**Addendum No. 2**  
**July 29, 2024**

Project: Brandon Valley Elementary School  
Brandon, South Dakota  
Project #3023

Architect: Architecture Incorporated

ENLARGED SITE PLAN - SOUTH PARKING

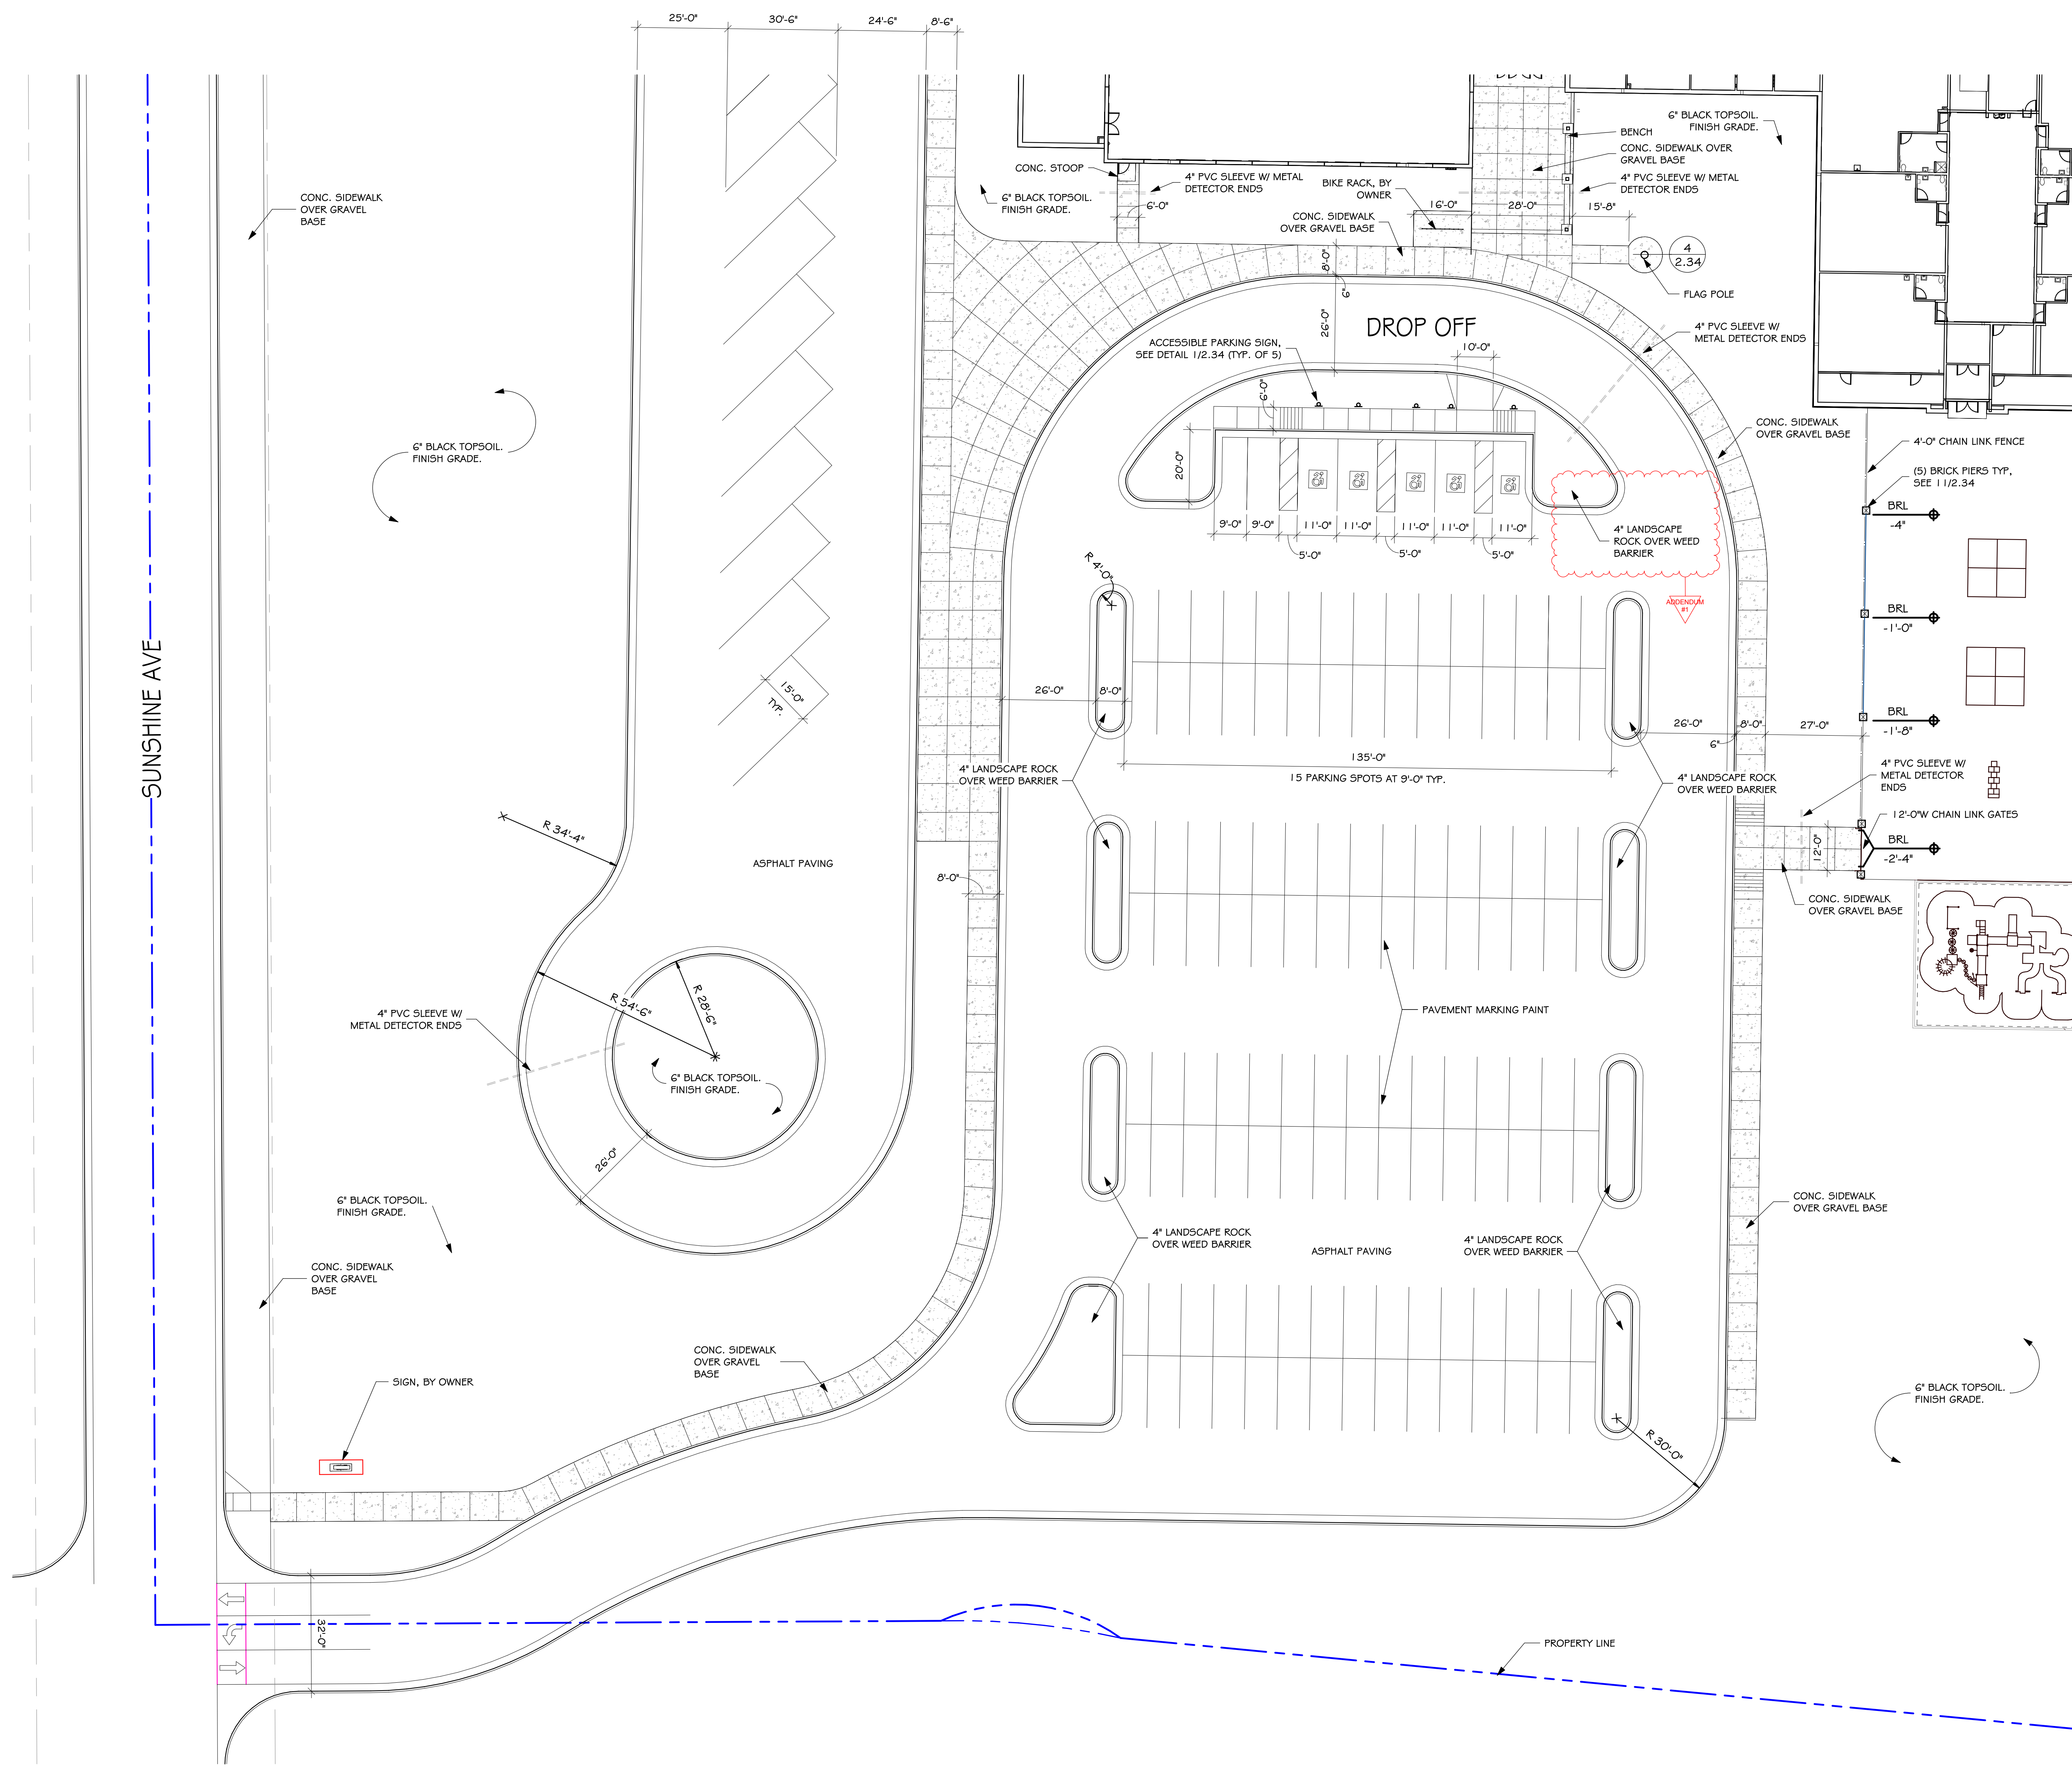
- 11) SHEET 2.31– ENLARGED SITE PLAN – SOUTH PARKING
  - a) Reference *revised* drawing Sheet 2.31, *revision* dated 7-23-2024, attached to the end of Addendum #2 for the following modifications:

- ii) Reference Item #5 in the Addendum #1 (Revised drawing Sheet 2.31 was not attached in Addendum #1).
- 12) SHEET 2.42 – STORM SEWER PLAN
  - a) Civil drawing Sheet 2.42 has been updated to reflect the modifications to storm sewer line and inlet originally shown along the east and south sides of asphalt pavements located east of the new bus garage.

STORM SEWER PLAN

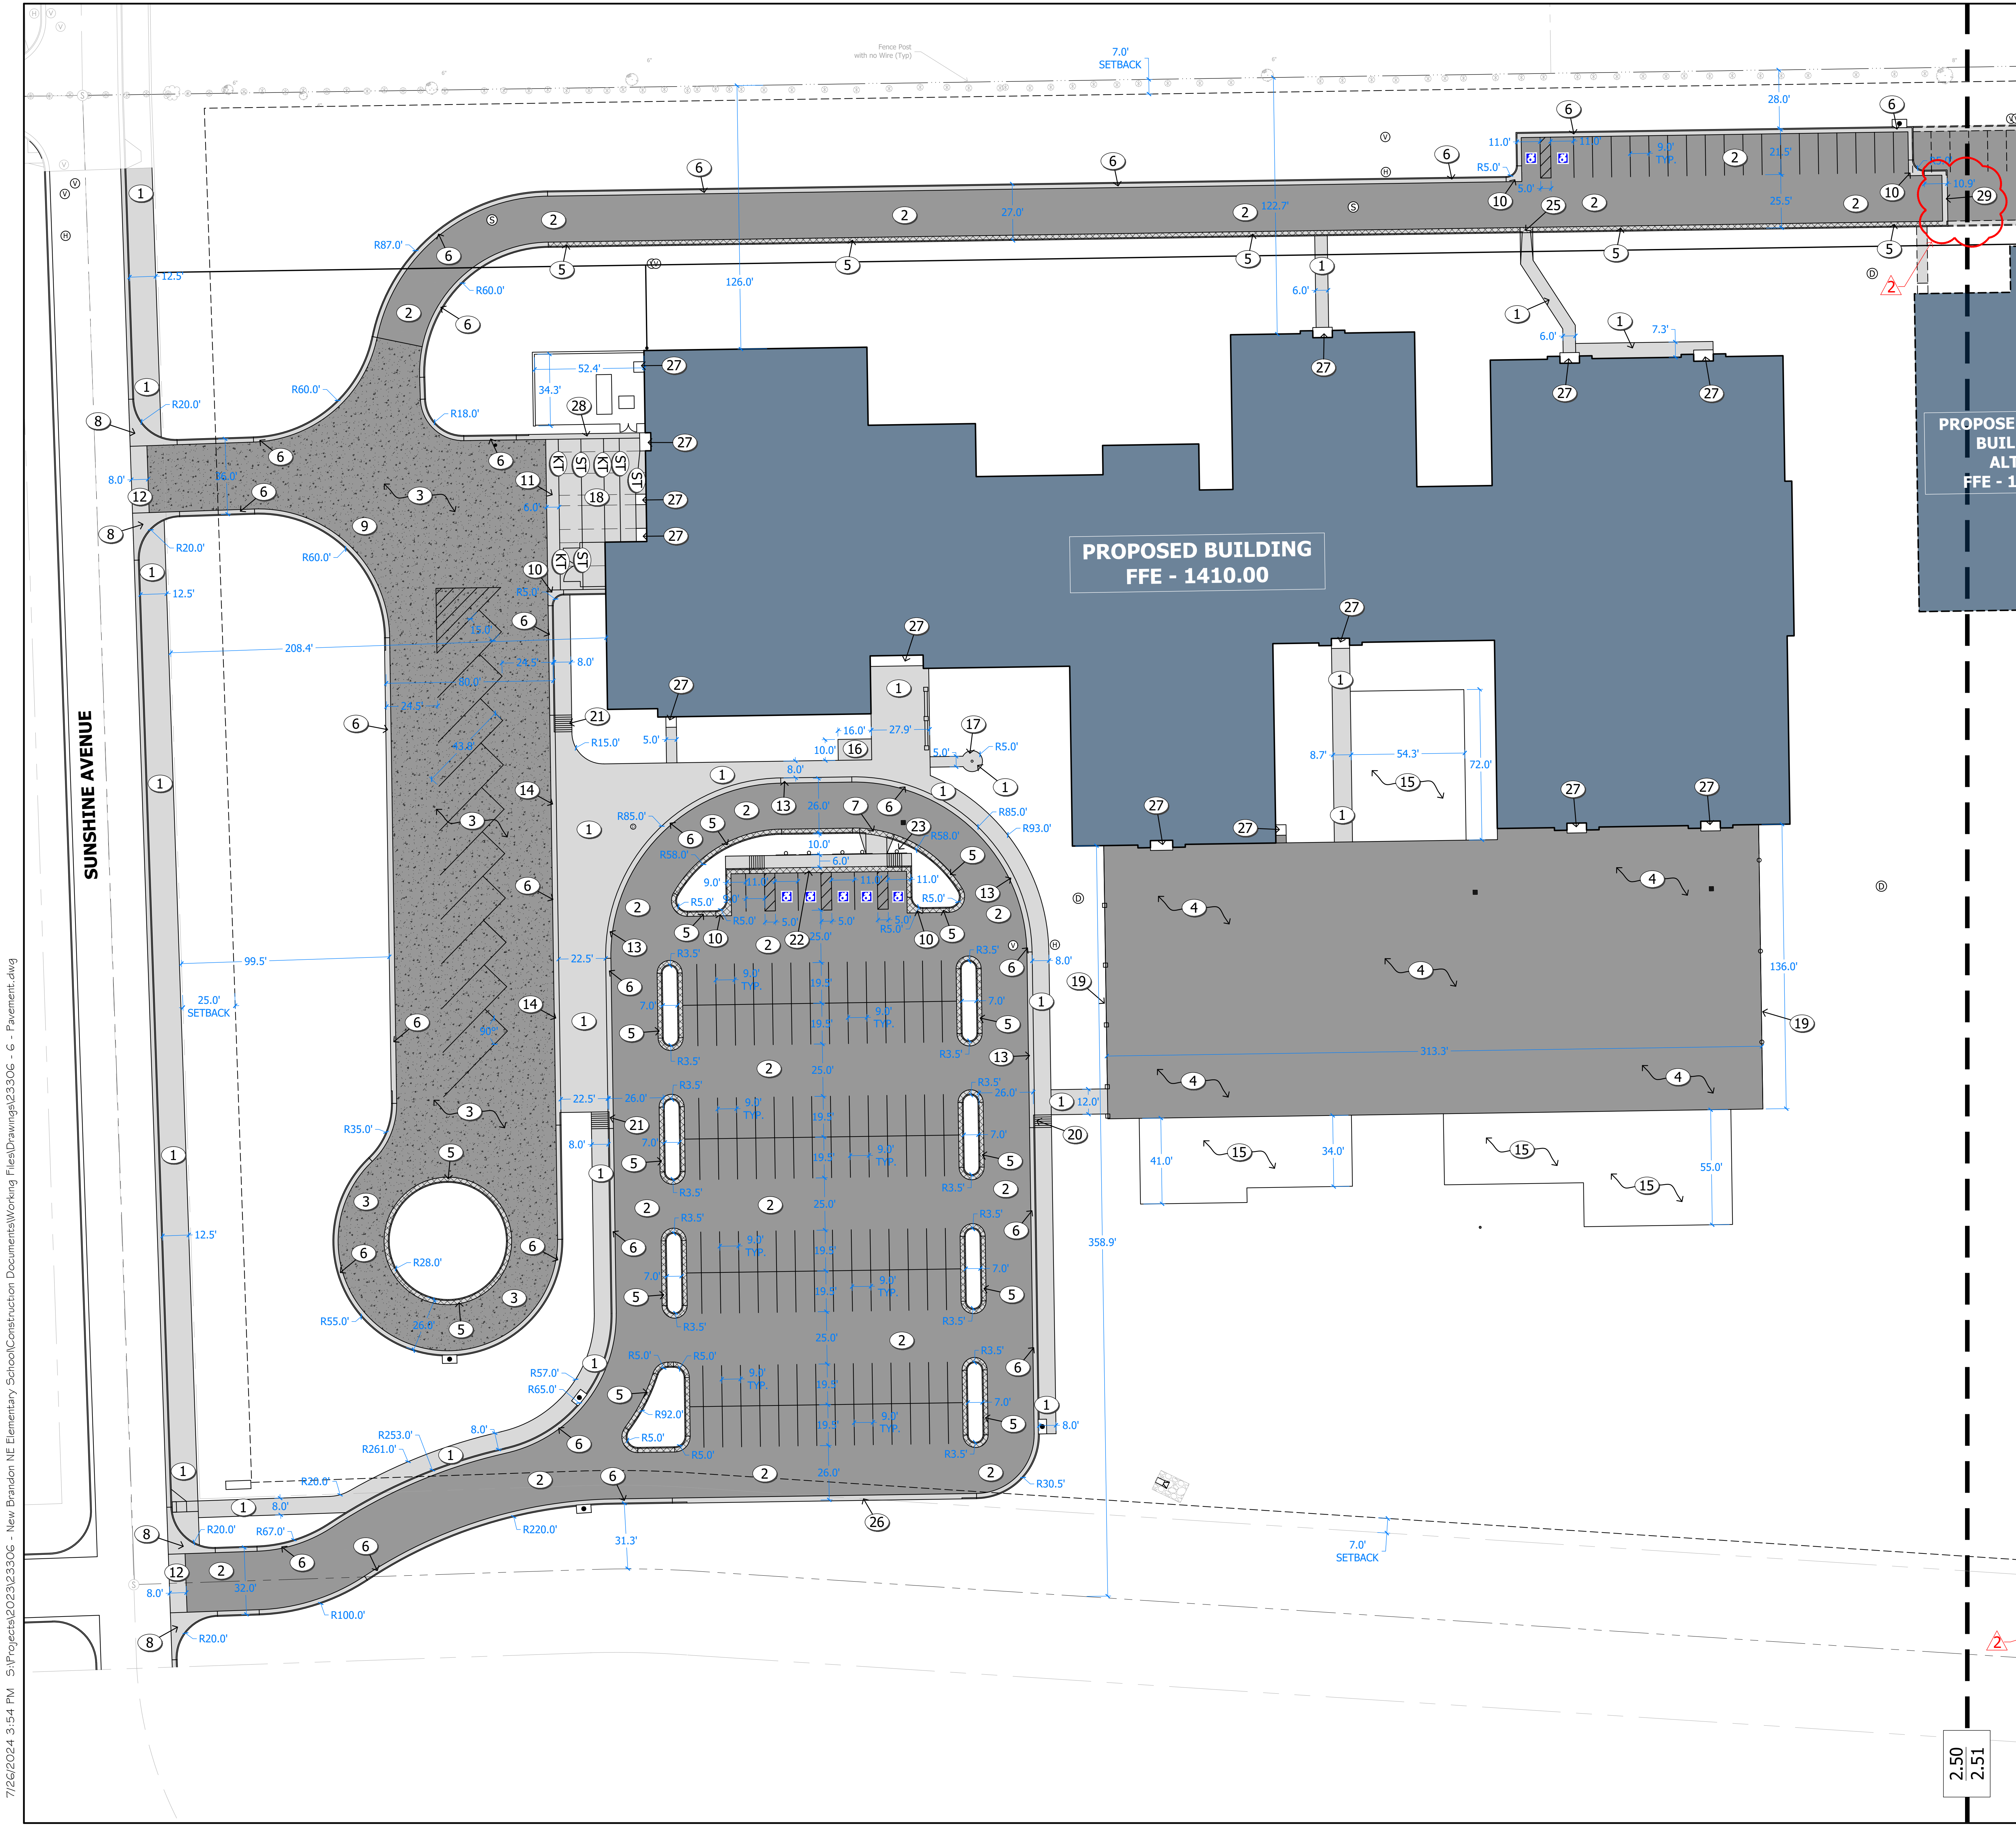
- i) Omit storm sewer line and inlet from bus garage parking lot to the pond.
- 13) SHEET 2.50 – PAVEMENT PLAN
  - a) Reference *revised* Civil drawing Sheet 2.50, *revision* dated 7-26-2024, attached to the end of Addendum #2 for the following modifications:

**2.51**

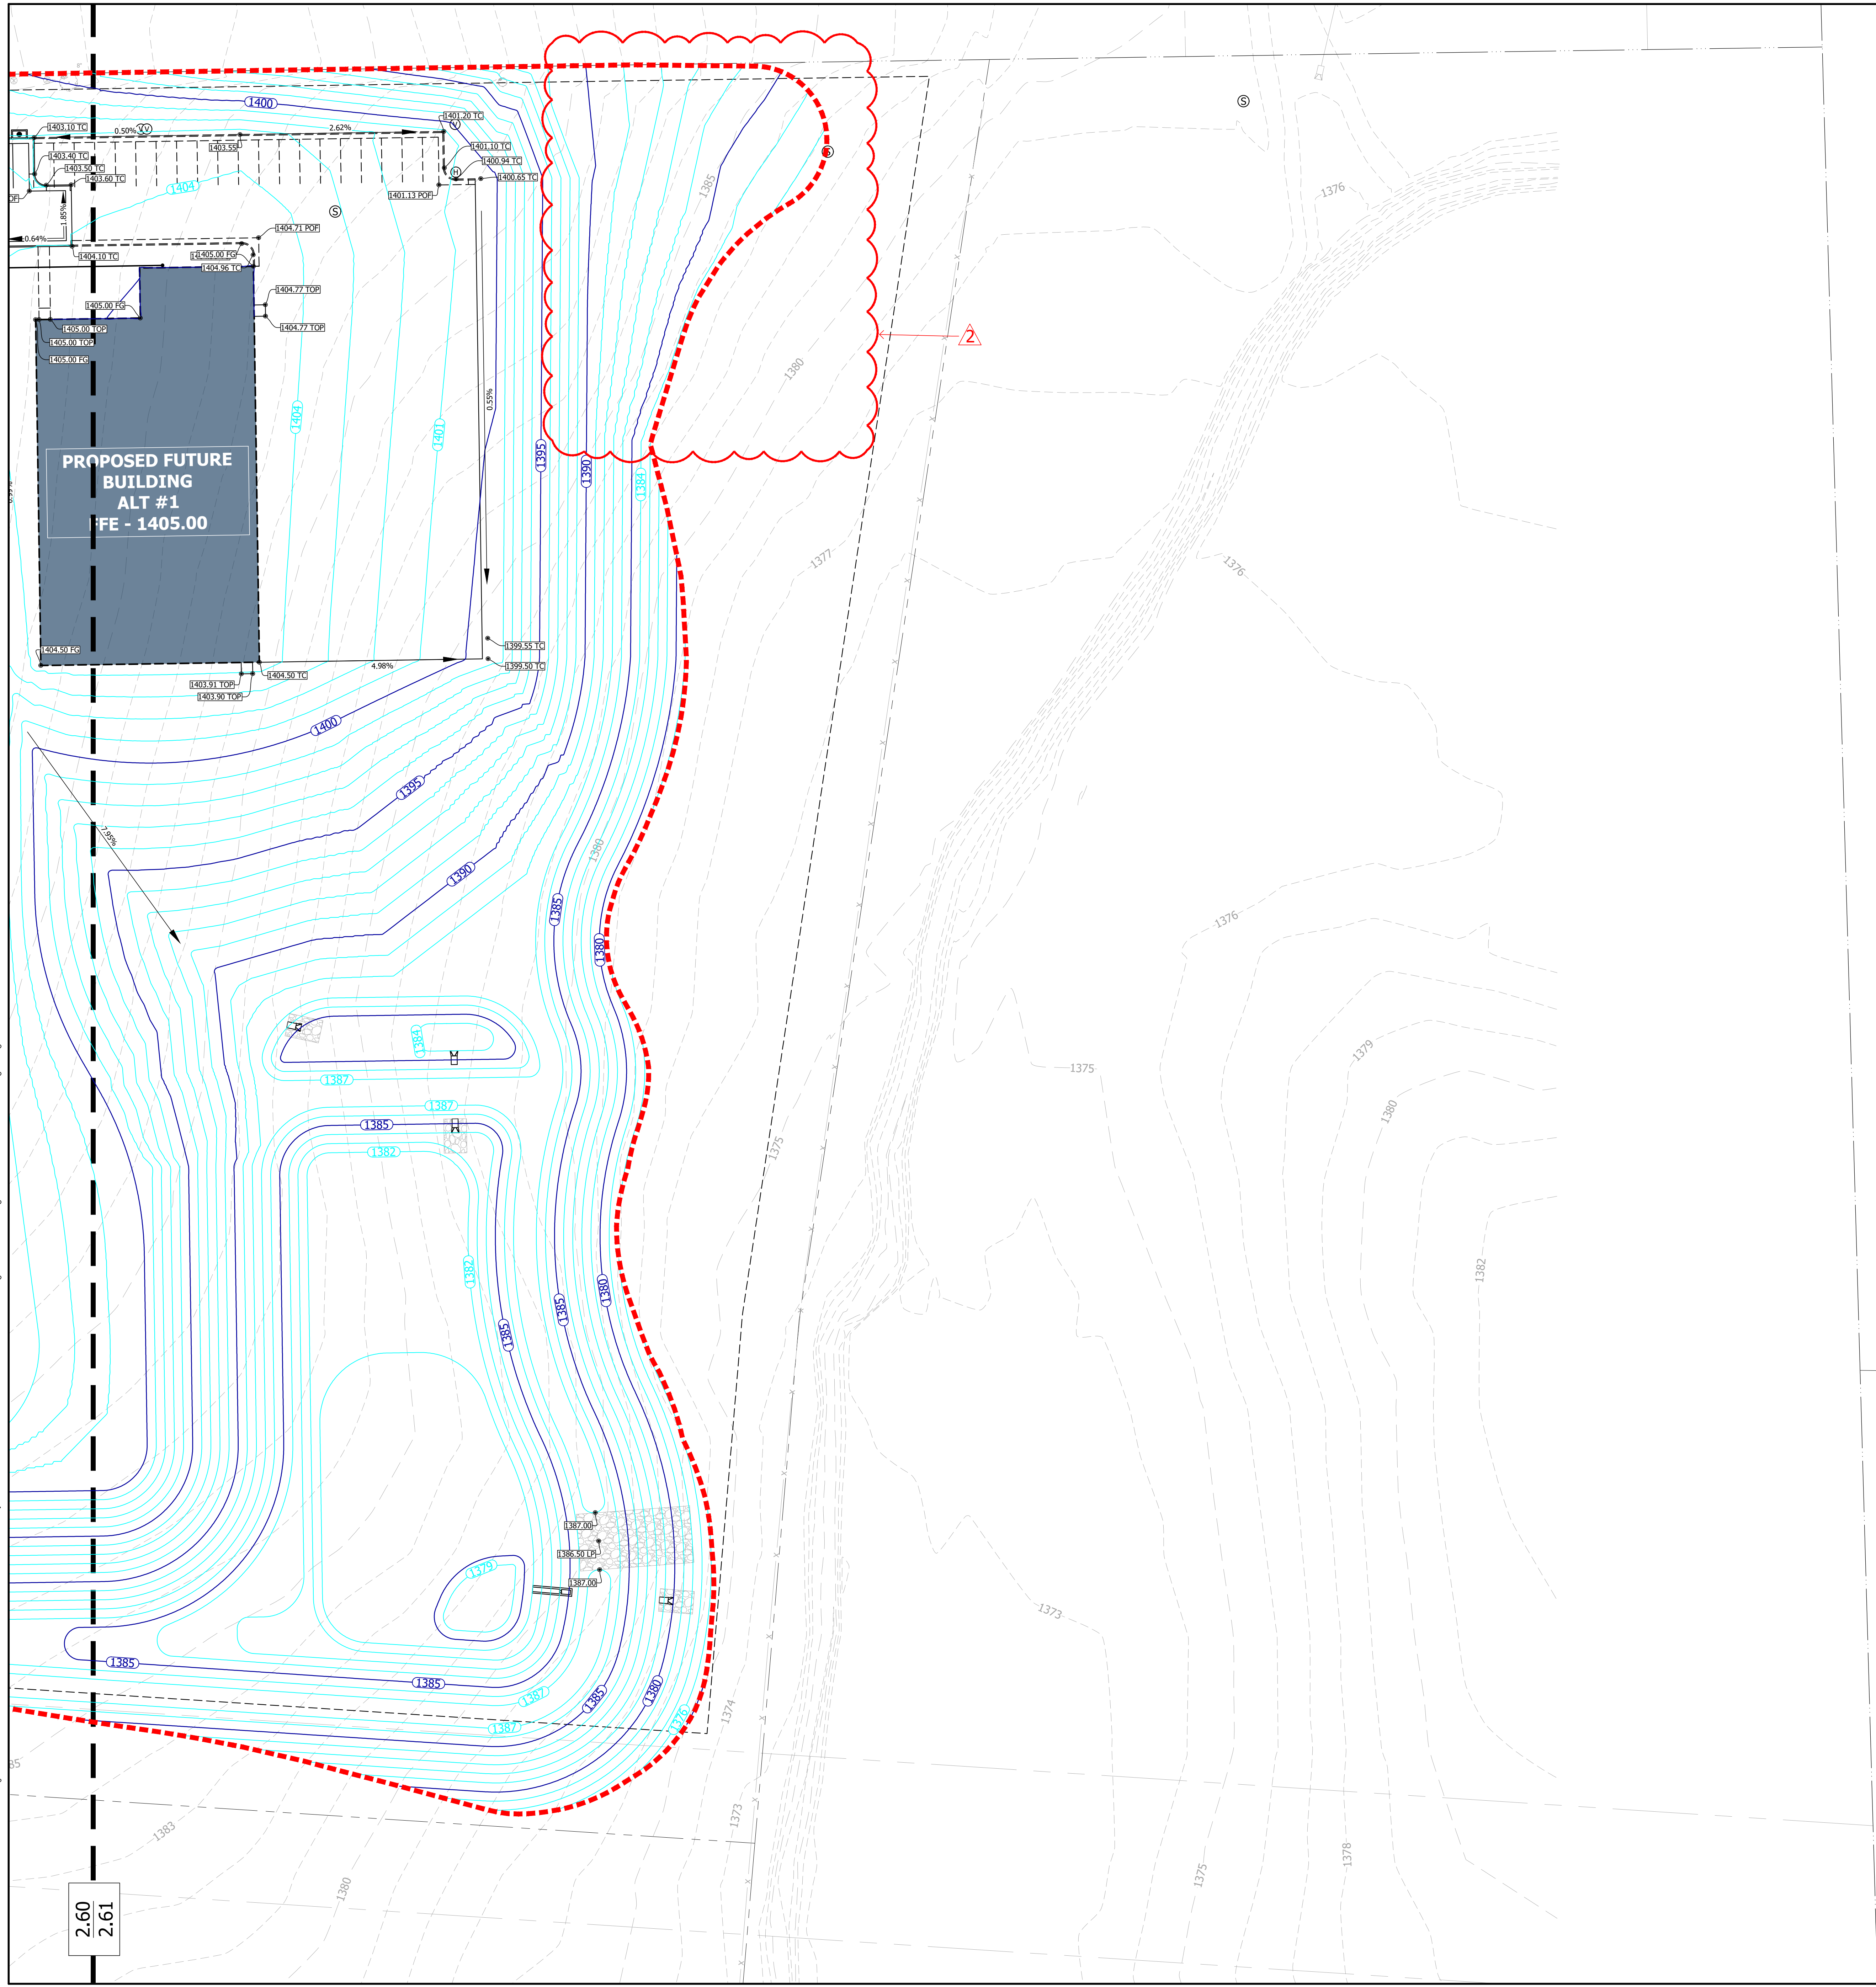
- ii) Disregard if Alternate #1 is accepted.
- 14) SHEET 2.51– PAVEMENT PLAN
- a) Reference *revised* drawing Sheet 2.51, *revision* dated 7-26-2024, attached to the end of Addendum #2 for the following modifications:

- i) Omit concrete curb & gutter originally shown along the east and south sides of asphalt pavements located east of the new bus garage.
    - ii) Provide 3' curb taper at northeast corner of the bus garage parking lot where the curb and gutter ends as indicated in the *revised* drawing.
